AGENDA

ST. TAMMANY PARISH PLANNING COMMISSION MEETING 6:00 PM - TUESDAY SEPTEMBER 8, 2020 ST. TAMMANY PARISH GOVERNMENT COMPLEX PARISH COUNCIL CHAMBERS 21490 KOOP DRIVE, MANDEVILLE, LOUISIANA

2020-2026-MSP

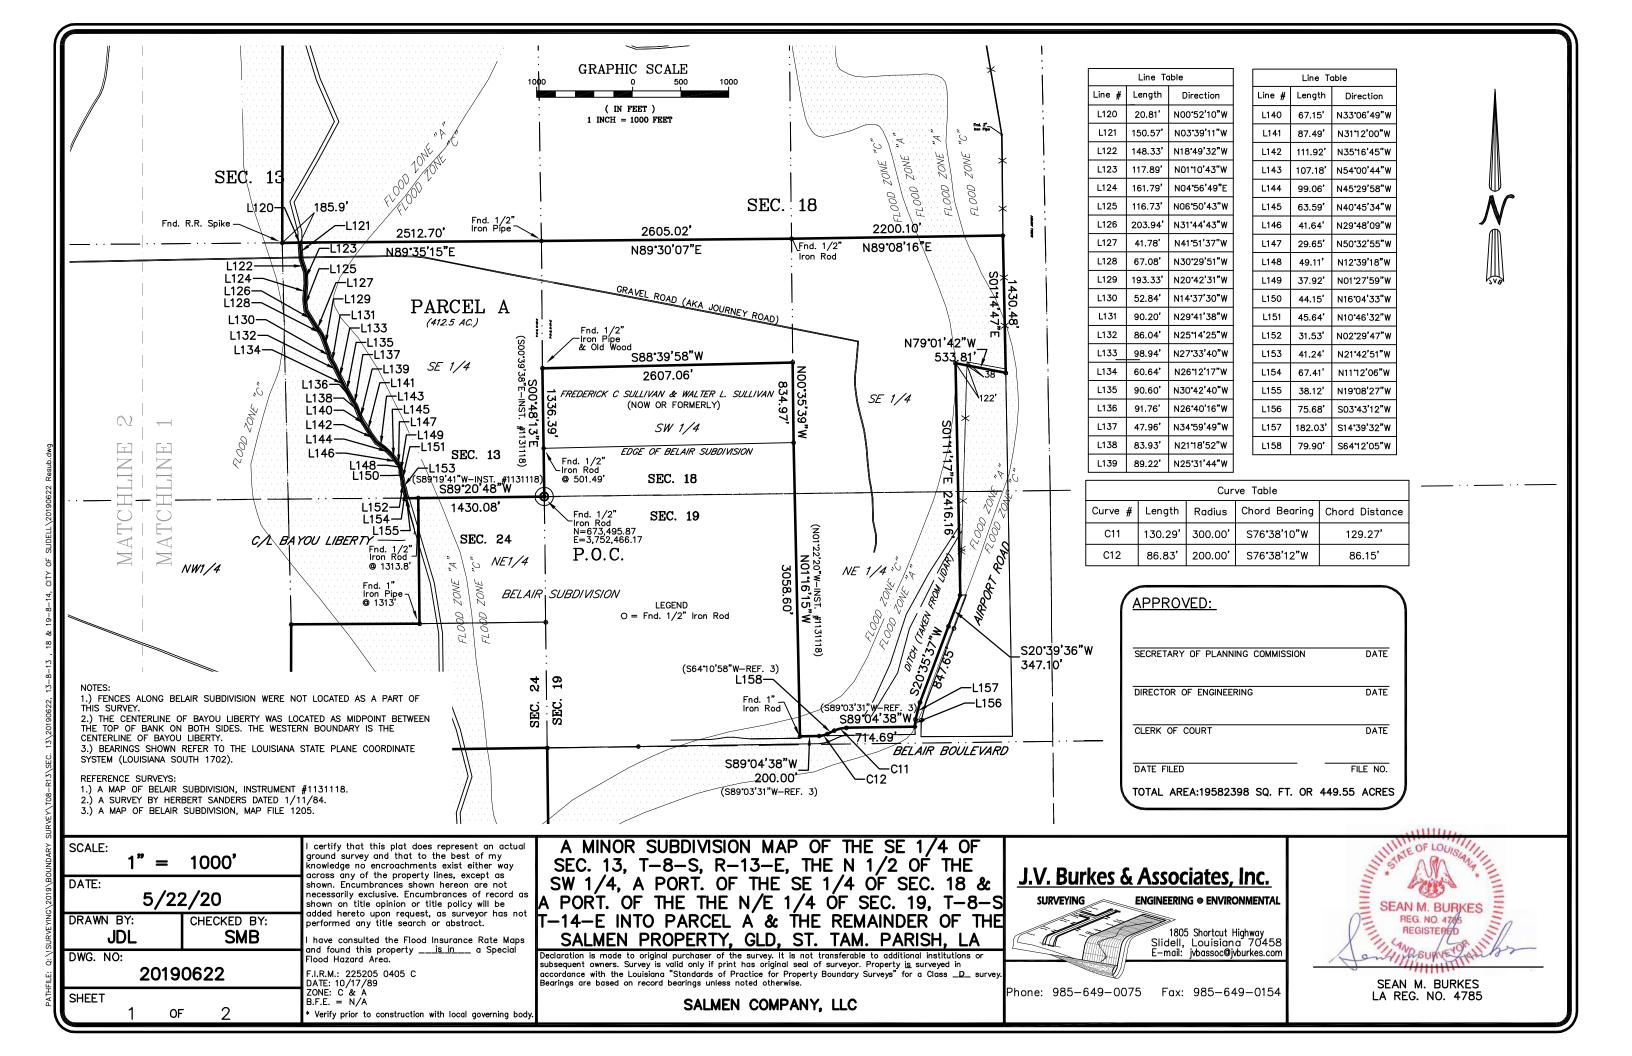
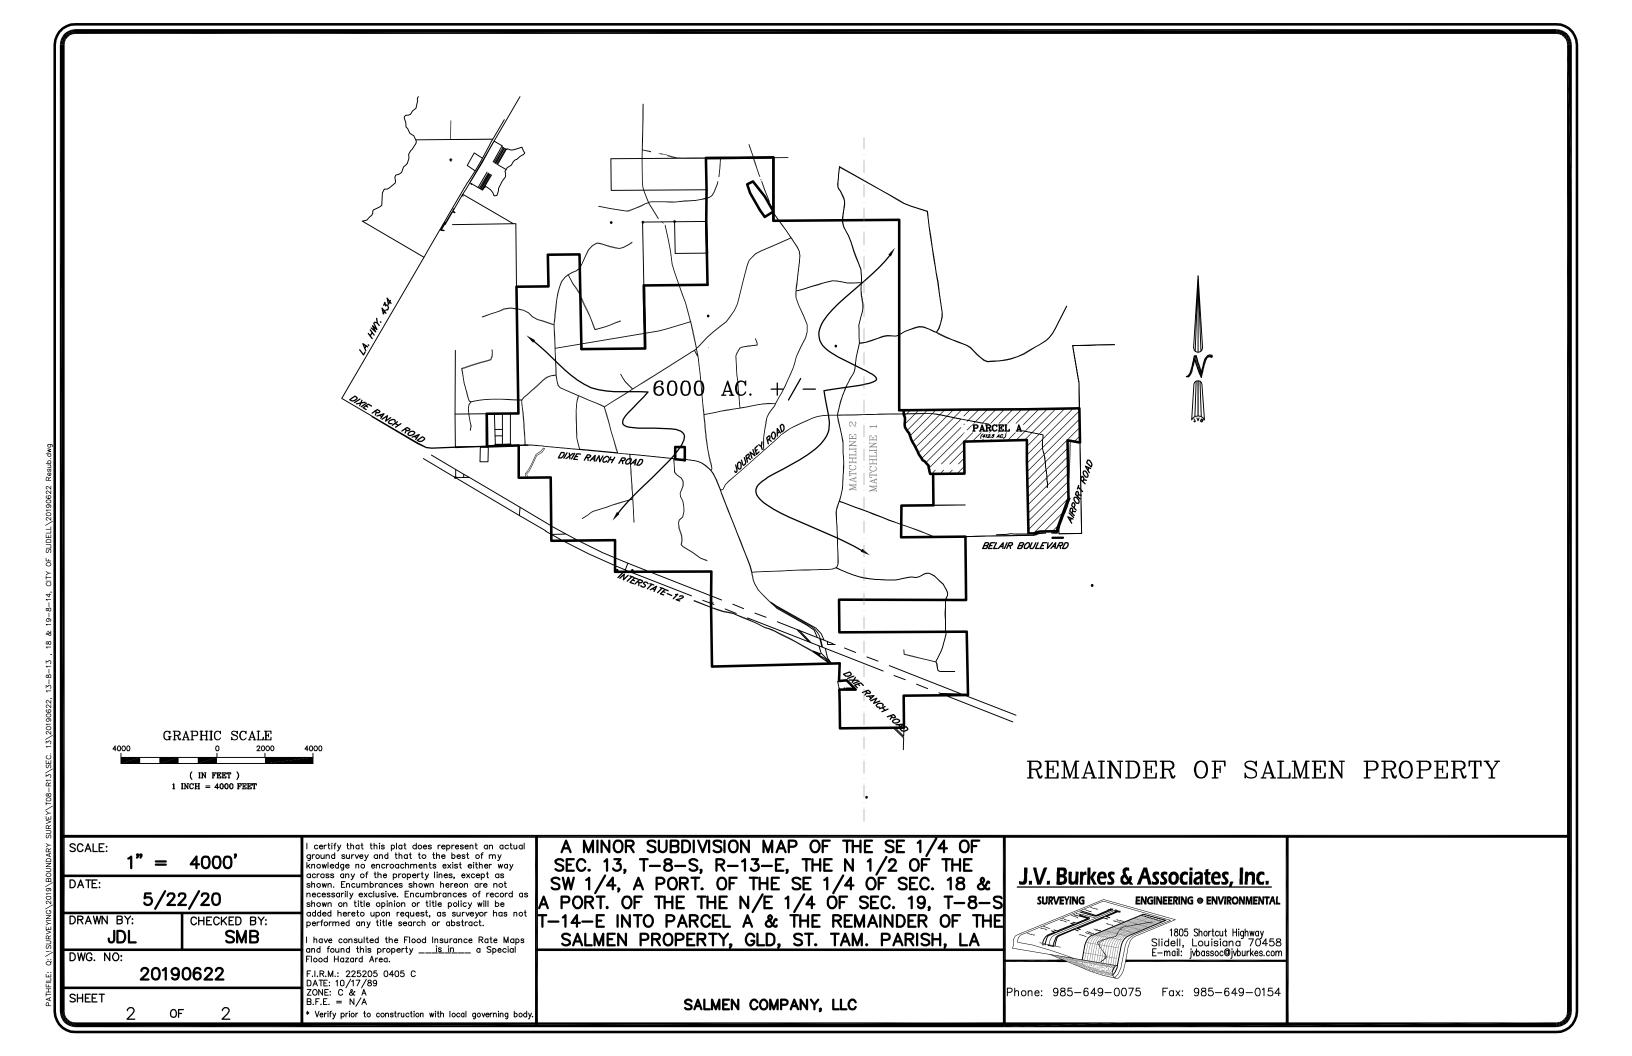
- 1. On Sheet 2, the roadway identified as "DIXIE RANCH RD" should read "N DIXIE RANCH RD".
- 2. The plat must be amended to include a signature line for the Chairman of the Planning Commission.
- 3. Identify the Range lines on the survey as R13E & R14E.
- 4. Update the dates on Sheets 1 & 2.
- 5. Correction required as follow: "A MINOR SUBDIVISION OF <u>A PORT. OF</u> THE SE ¹/₄ OFSEC. 19, T-8-S, <u>R</u> T-14-E....

2020-2023-MRP

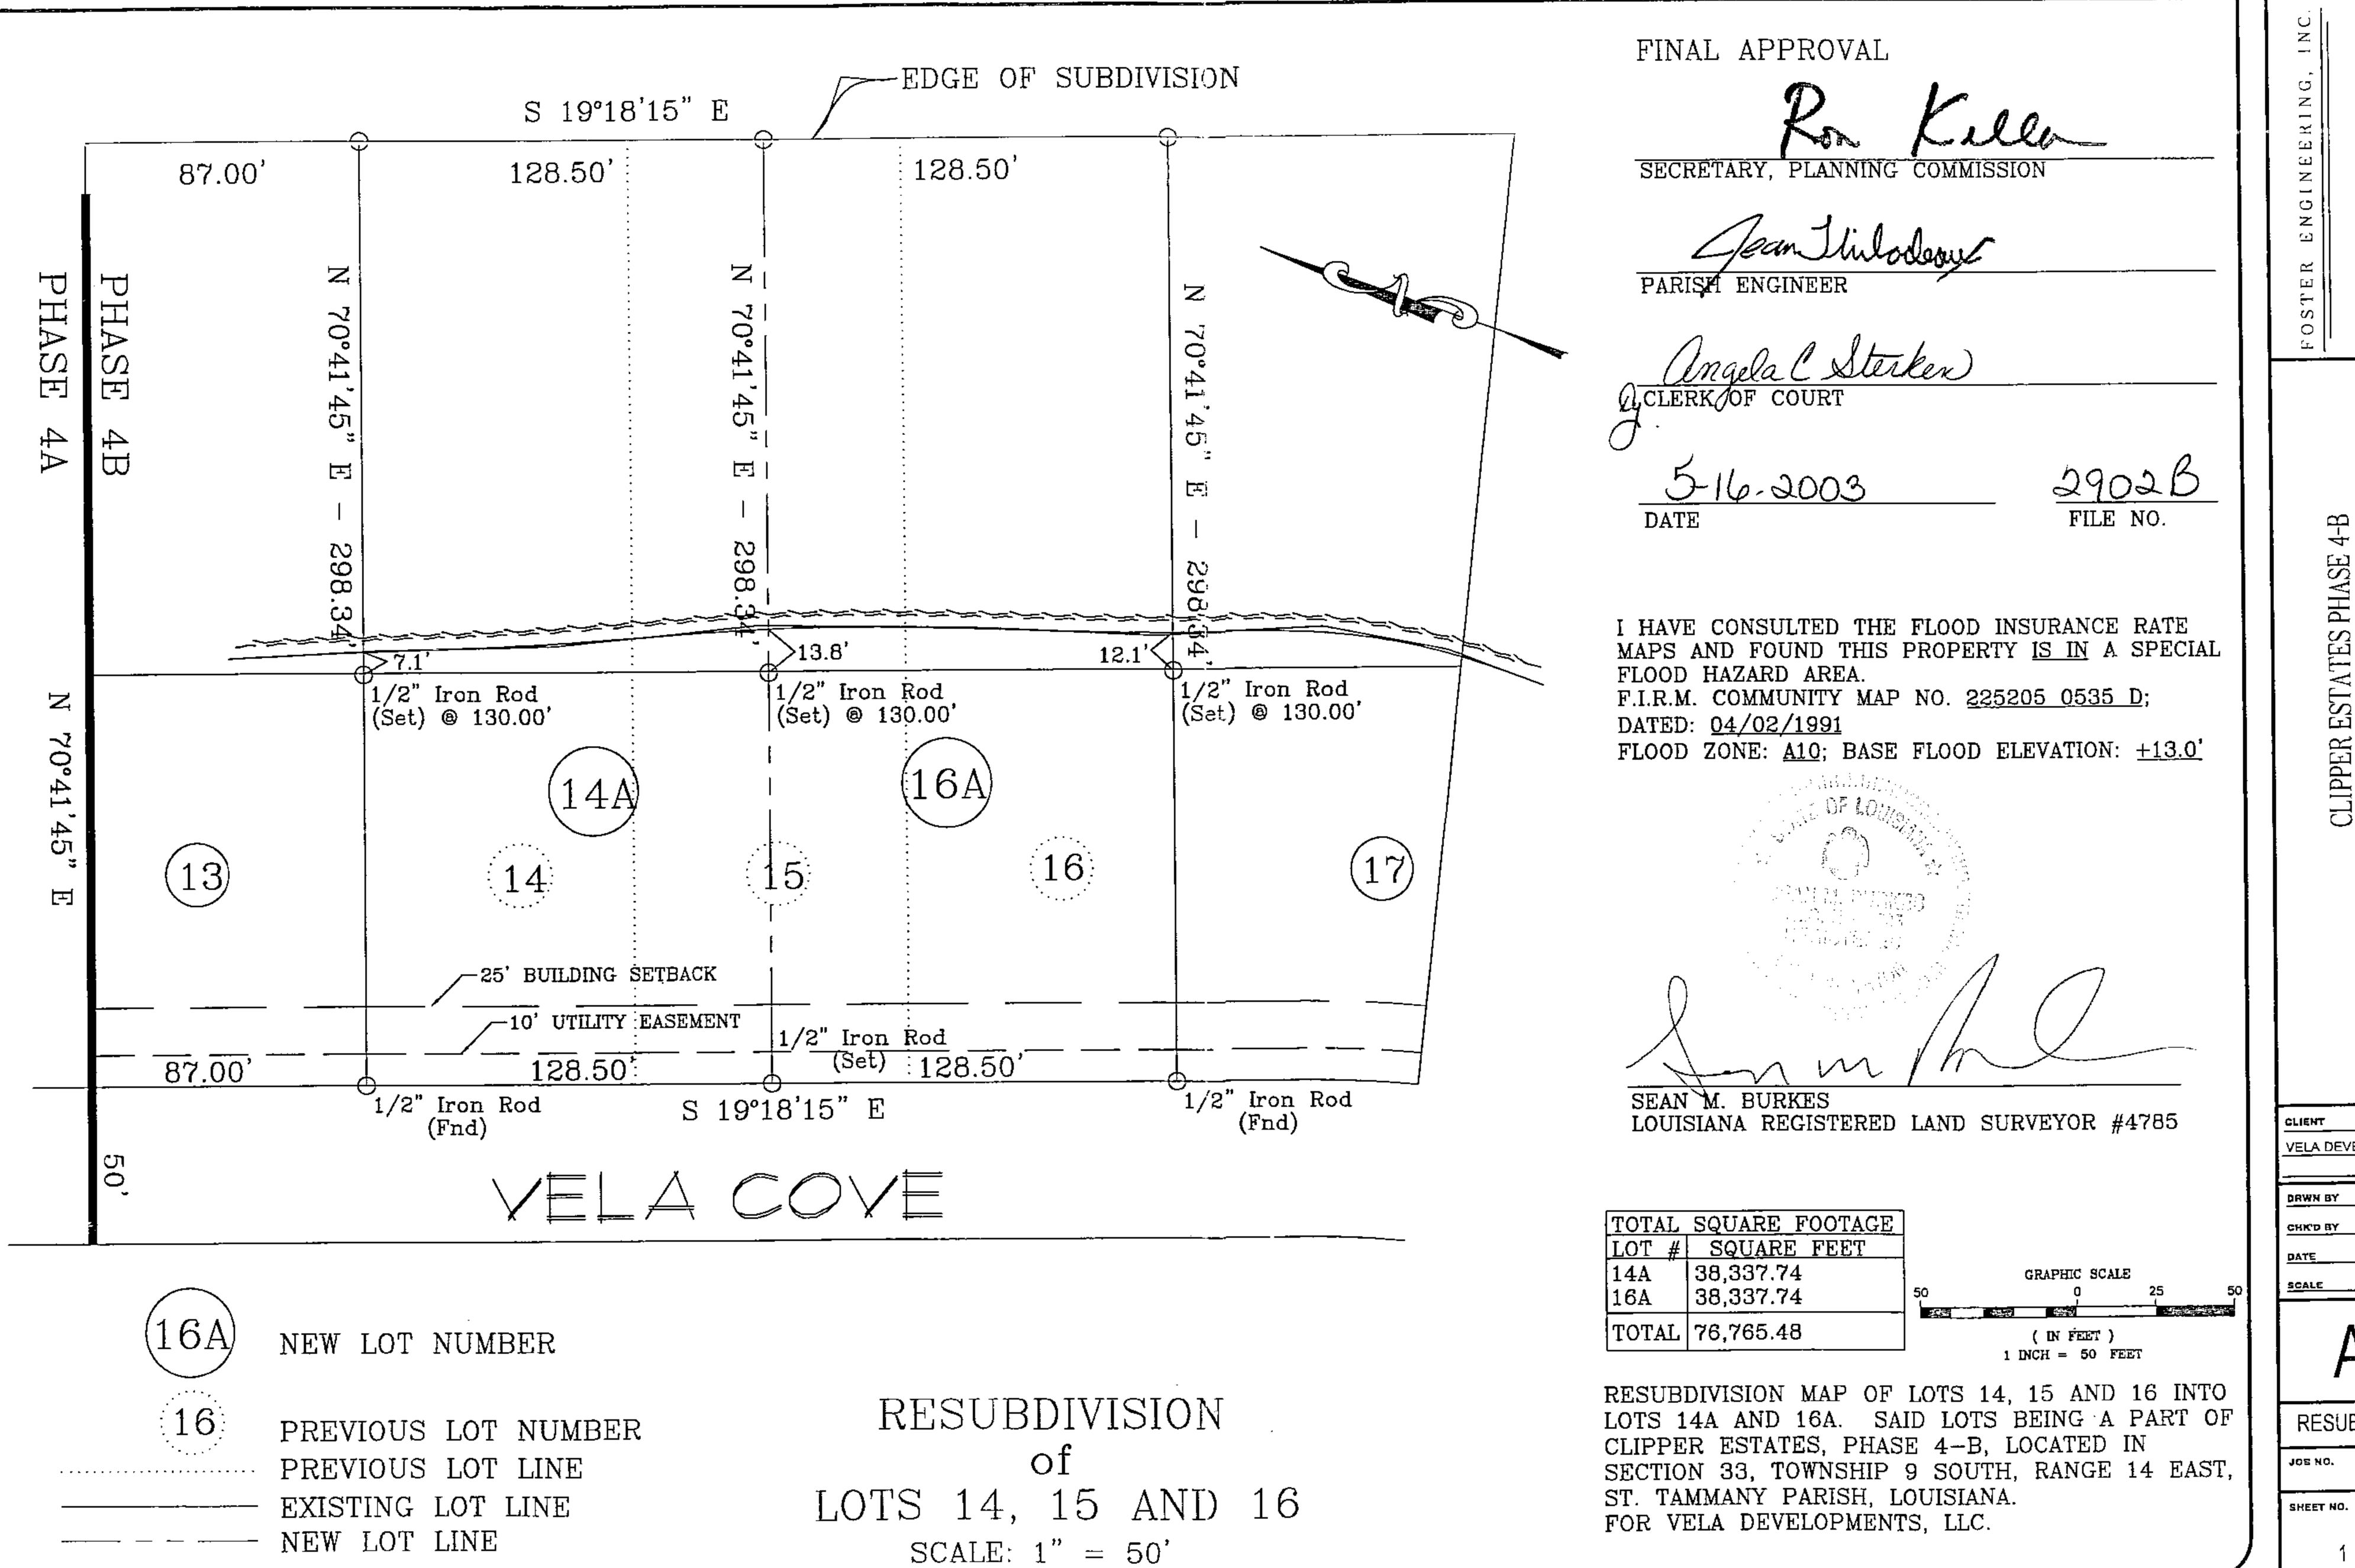
The owner is requesting to resubdivide Lots 14A, & 16A and 15A & 17A into Lots 14A-1, 16A-1 & 17A-1. The objective of the request is to allow for the attached survey dated 08/13/2020 to correct the previously recorded surveys.

- Lots 14, 15 & 16 were resubdivided and resulted in the creation of lots 14A & 16A, as shown on the attached survey recorded in 2003.
- Lots 15, 16 & 17 were subsequently resubdivided and resulted in the creation of lots 15A & 17A as shown on the attached survey recorded in 2004. The 2004 survey did not take into consideration the previously recorded survey in 2003 and omitted Lot 14.
- The survey showing lots 15A & 17A, recorded in 2004, also caused the creation of an unbuildable lot (as shown on the attached revised survey dated 08/13/2020, lot 17A is bisected by a 20' drainage servitude).
